John Stacey

Interested party :

Further Submission dated 07/07/2026

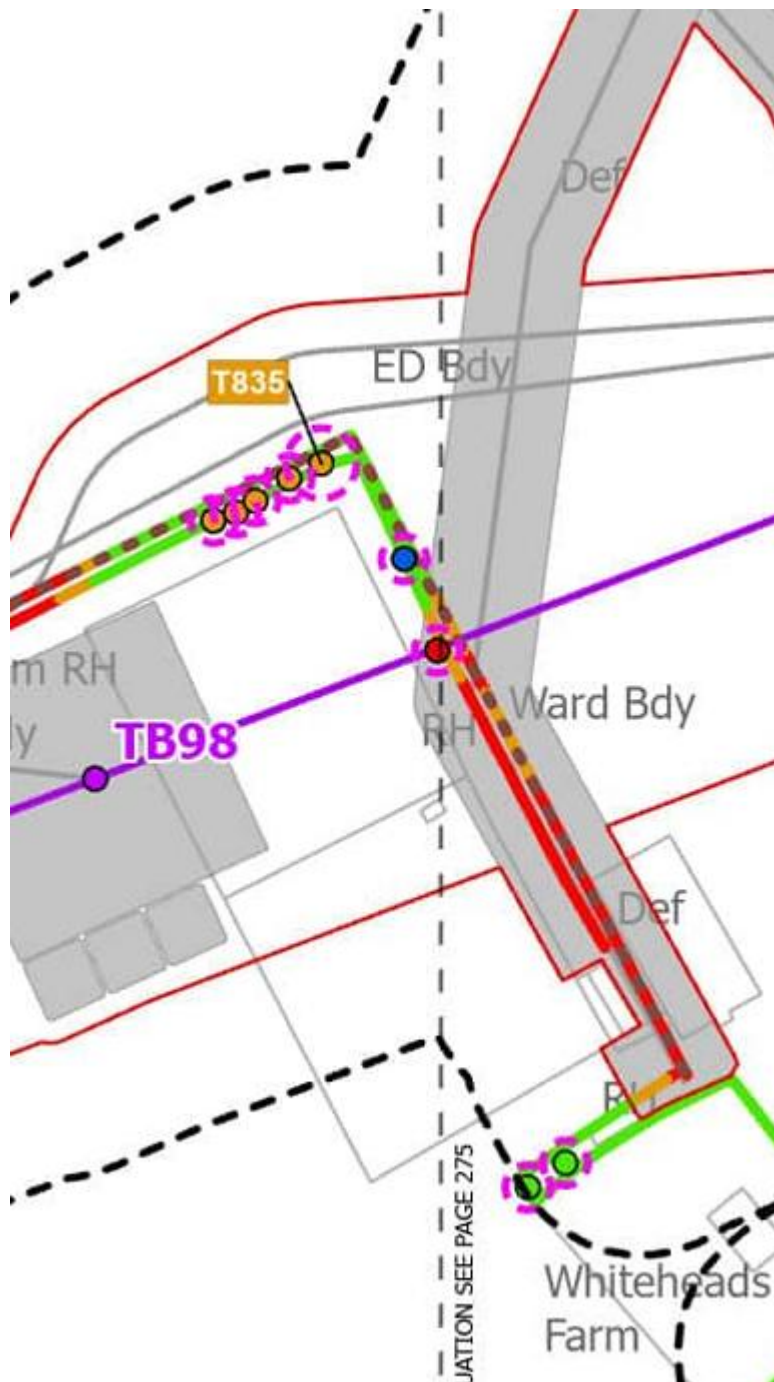
I have attached a photo which shows the trees that will be removed in the field corner between TB97 and TB 96 and are classified as low quality and will not be part of the trees that NG classified that they will plant 3 for 1.

As can be seen from the photo at least a few of these trees should be categorised as moderate quality

NG response in REP-194 *“The trees between TB96 and TB97 have been predominantly categorised as low quality, with seven trees of moderate quality unaffected by the Project, labelled as T826–T832 in 6.13.A6 Environmental Statement Appendix 13.6 - Arboricultural Impact Assessment (AIA) Figure A13.6.1 - Arboricultural Impact Assessment [REP1-065].”*
